TUTHILL SUBDIVISION, LONG ADDITION TO

APPLICATION NUMBER 15 DATE October 15, 2009

DETAIL SITE PLAN

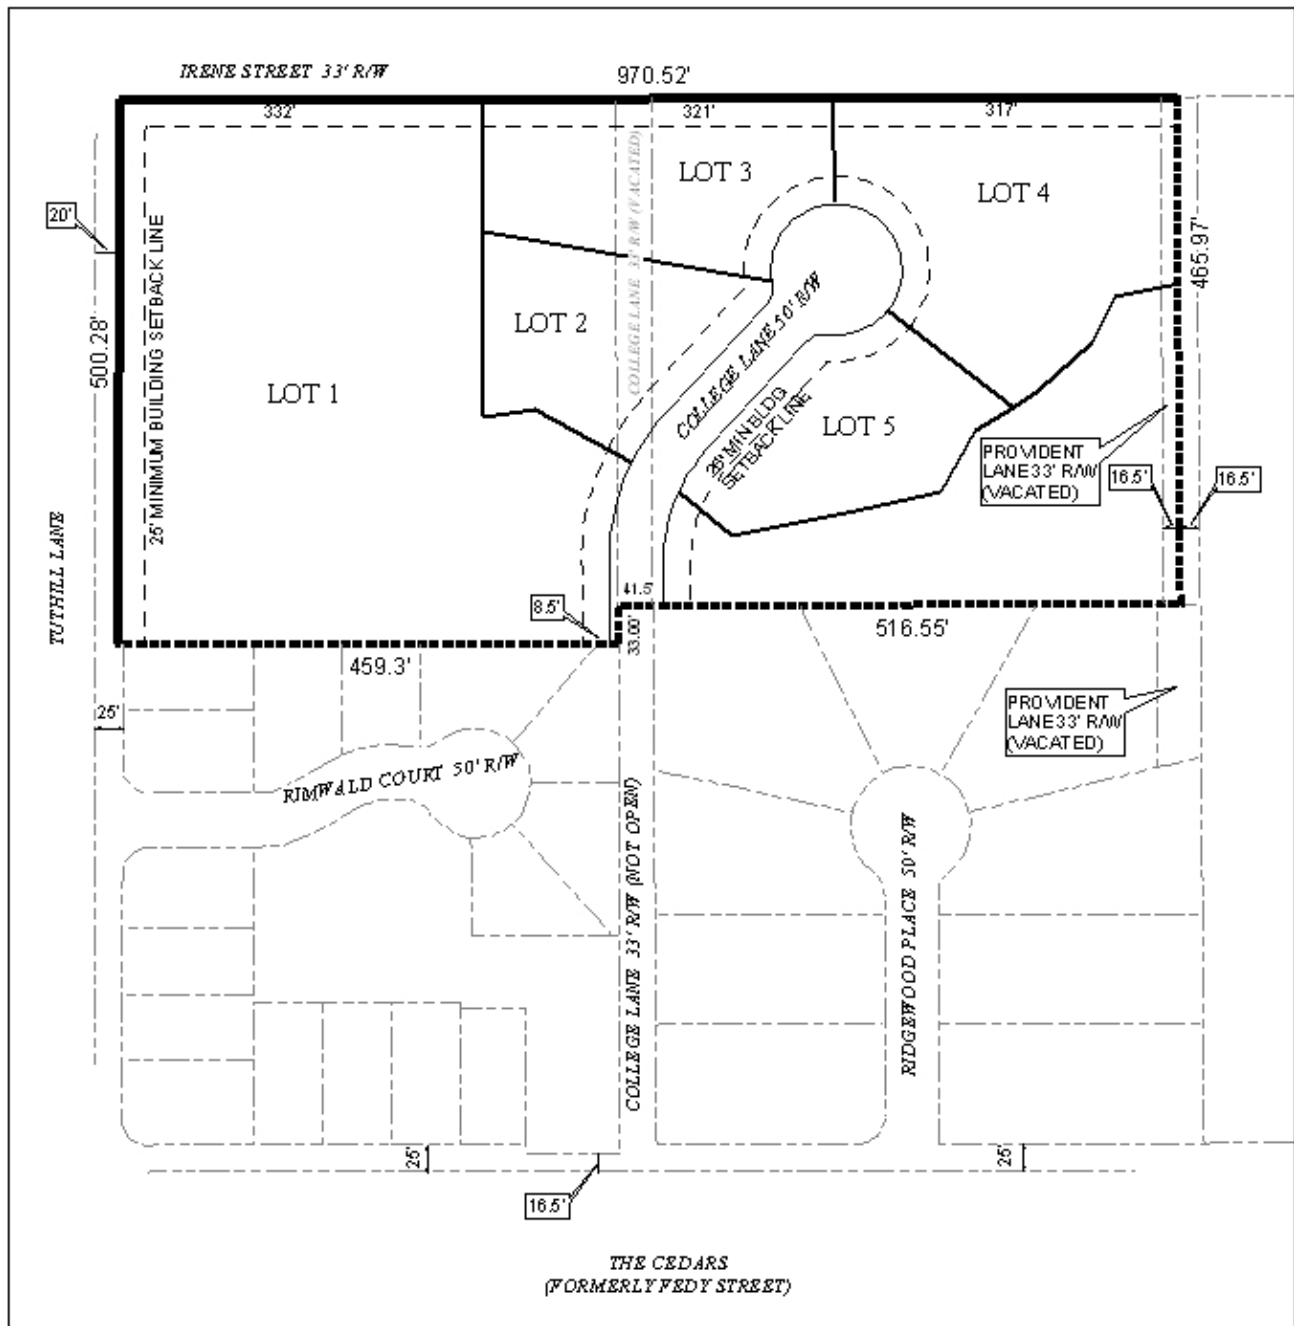
It appears that the proposed lots meet the minimum size requirements as regulated by Section V.D.2 of the Subdivision Regulations, however, the proposed lot sizes are not indicated on the plat. The lot sizes, in square feet, or a table containing the same information, should be indicated final plat, if approved.

The applicants propose to construct a development which connects to the existing unopened right-of-way of College Lane. The plat depicts the proposed new right-of-way of College Lane on the site as 50 feet which will connect to the existing, unopened right-of-way, depicted as being only 33 feet. Section V.B.14 of the Subdivision Regulations requires a minimum right-of-way width for minor streets provided with curb and gutter to be 50 feet.

Properties on either side of the existing right-of-way are already developed with dwellings. As none of these properties are included in this application, it appears that the applicant intends to construct a city-standard street on a sub-standard right of way. Additionally, the existing College Street right-of-way as well as the proposed extension would result in a closed-end street longer than 600-feet, in violation of Section V.B.6 of the Subdivision Regulations. It should be noted that the existing 33-foot right-of-way of College Lane is also insufficient under the Village of Springhill Traditional Center District regulations.

Without a dedication of each property owner along the existing College Lane right-of-way, together with inclusion of the said properties in the subdivision, the proposed subdivision would have inadequate access. It should be noted that if the applicant were to include the requisite lots to obtain necessary right-of-way, the application would need to include Lots 4-6 of Rimwald Court Subdivision (MB 35, Page 47), the metes and bounds parcel at the Northwest corner of where the College Lane right-of-way and The Cedars meet, Lot 6 of Ridgewood Revised Lot 6 Subdivision (MB 68, Page 8), Lots 7-8 of Ridgewood Subdivision (MB 5, Pages 219-221), and Lot 9 of Ridgewood Subdivision, Resubdivision of Lot 9. Further, each of these lots would be required to dedicate enough right-of-way to provide 25 feet from the centerline of College Lane.

Based on the previously stated information, if access to the subdivision is only provided via the substandard right-of-way of College Lane, access will not be adequate as per Section V.B.14 of the Subdivision Regulations. An alternative for the applicant to consider would be revising the configuration so that the subdivision is accessed from Tuthill Lane via Irene Street (with proper right-of-way dedication), and access to The Cedars eliminated, except for a street stub connecting to the unopened right-of-way.

Finally, the applicant is indicating that the proposed Lot 1 would cross the proposed College Lane extension. Lots cannot cross rights-of-way, and therefore, this should also be revised to reflect an additional lot in the subdivision, and this lot would also have to meet all lot regulations.

- 1) The proposed subdivision would have inadequate access due to substandard rights-of-way for both College Lane and Irene Street as per Section V.B.14 of the Subdivision Regulations;
- 2) The proposed extension to College Lane would create a closed-end street longer than 600 feet and thus not in compliance with Section V.B.6 of the Subdivision Regulations;
- 3) The proposed Lot 1 crosses a public right-of-way; and
- 4) The comments made by City Engineering: *The City of Mobile Engineering Department is in opposition to the subdivision as proposed for the several reasons. A minimum ROW*

width of 50 feet will be required for the entire length of College Lane. Due to the topography in the area of the north portion of Lob 6 of Ridgewood Place (207 Ridgewood Pl), the COM Engineering Department will require additional ROW in this area to allow for a maximum slope of 3:1 to tie into existing ground and to also account for any drainage from the required slope. There is not enough information for the COM Engineering Department to evaluate its concerns of how the existing drainage in the area will be handled in relation to the proposed street and subdivision as well as the effects on the downstream properties. It appears that construction of a large culvert will be required for the proposed College Lane north of Ridgewood Place Subdivision. The applicant will need to coordinate with the COM Engineering Department concerning the location of and widths of all required drainage easements across the property. Analysis of the receiving downstream storm water system will be required and the applicant will be required to provide enough measures and adequate detention to avoid any negative impacts on downstream properties. Upgrading downstream drainage systems may be required depending on the current condition and capacity of the receiving storm water system(s).
